Village of Downers Grove

Report for the Village Council Meeting

Subject	1205 - 1219 Ogden Avenue – Vacation of Public Alley, Final Plat of Subdivision, Planned Unit Development, Zoning Map Amendment and a Special Use
Submitted By	Stan Popovich, AICP, Director of Community Development

1.) View from Garage, No sound barrier will be present, direct residential exposure of cars, customers, noise and lights.

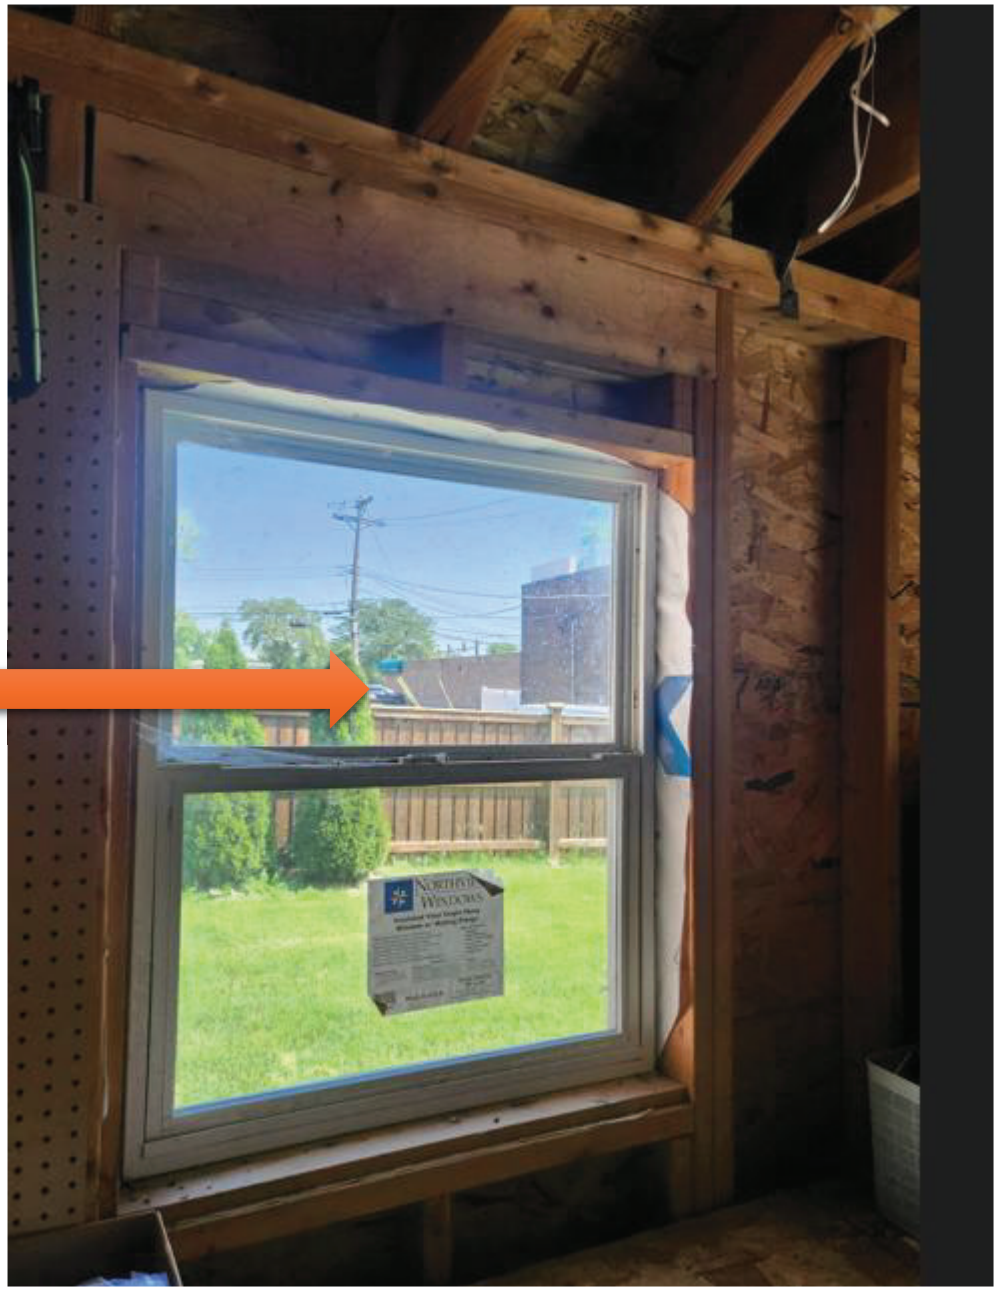
Where the Dutch brothers building will be located as well as menu, employees, customers, and walk up window.

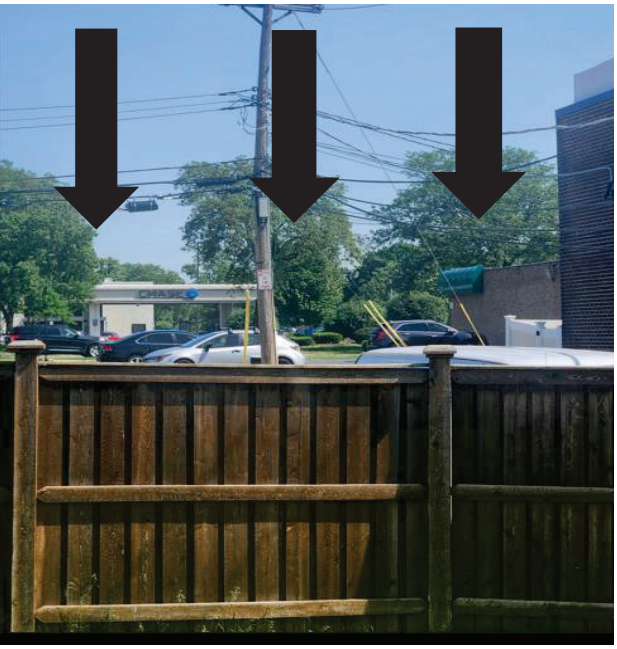
2.) View from behind our garage, where we have an active play area for our children with a swing set, No sound barrier will be present, direct residential exposure of lights, cars, customers, and constant noise (4:30am-11:30pm/12am). Cars will face directly into our yard due to the right turn from Ogden to sit and wait to enter the drive-thru line. (Constant flow of cars facing into our yard and home AM to PM).

Where cars will turn in off of Ogden to wait to turn left into the drive thru lane and cars waiting in drive thru lanes.

3.) View from one angle of our backyard patio. No sound barrier will be present, direct residential exposure of lights, cars, customers, and constant noise (4:30am-11:30pm/12am).

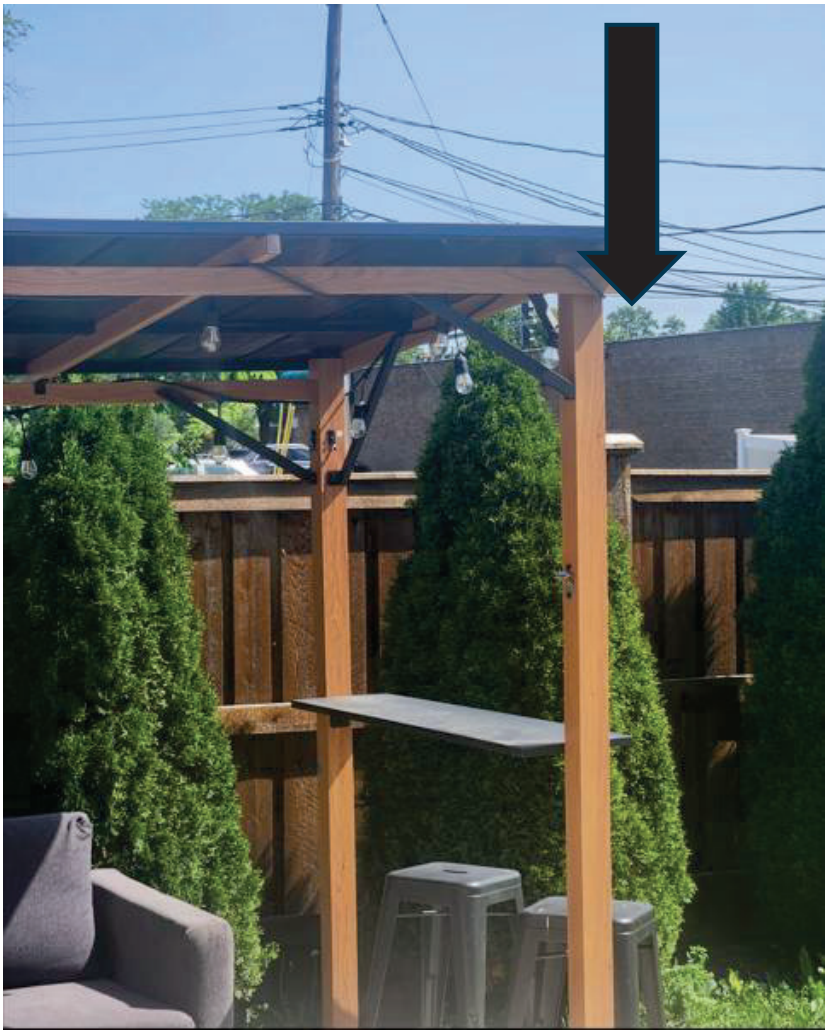
Where building, walk-up window, as well as drive-thru waiting lines will be in view.

4.) View from children's playroom. No sound barrier will be present, direct residential exposure of lights, cars, customers, and constant noise (4:30am-11:30pm/12am).

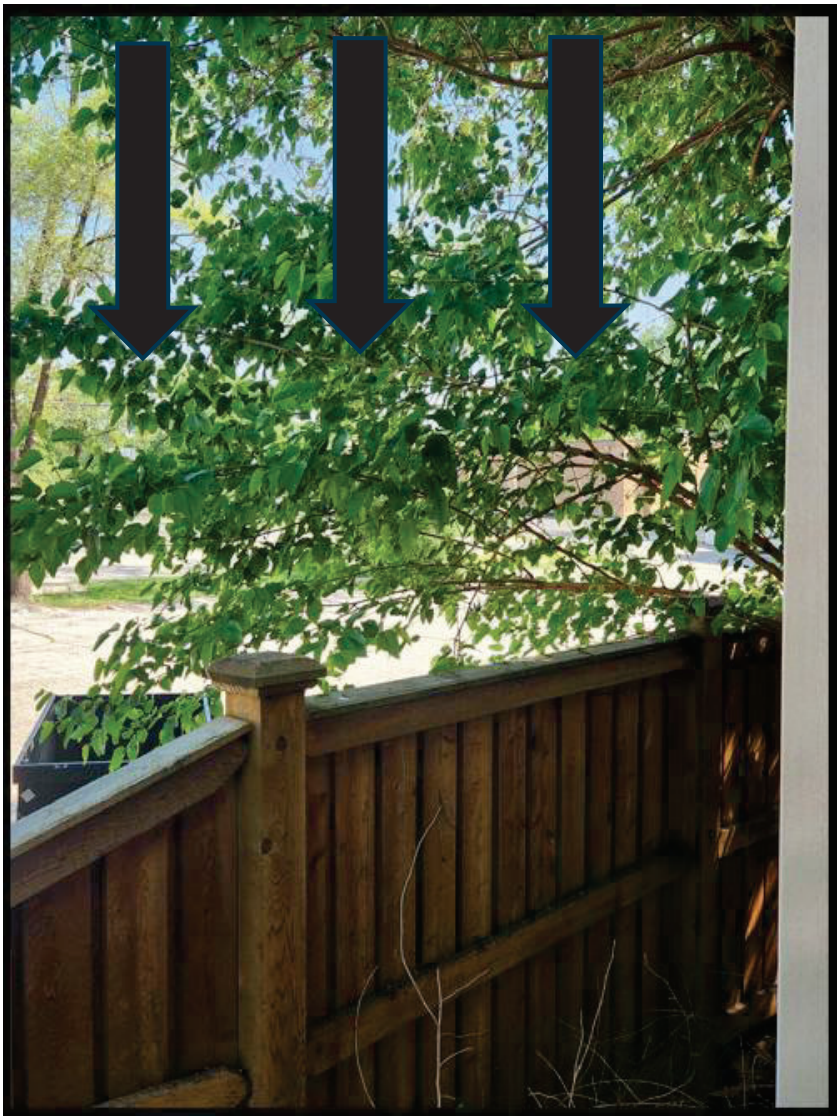
Once the leaves fall off the trees, the view will be extreme of all issues.
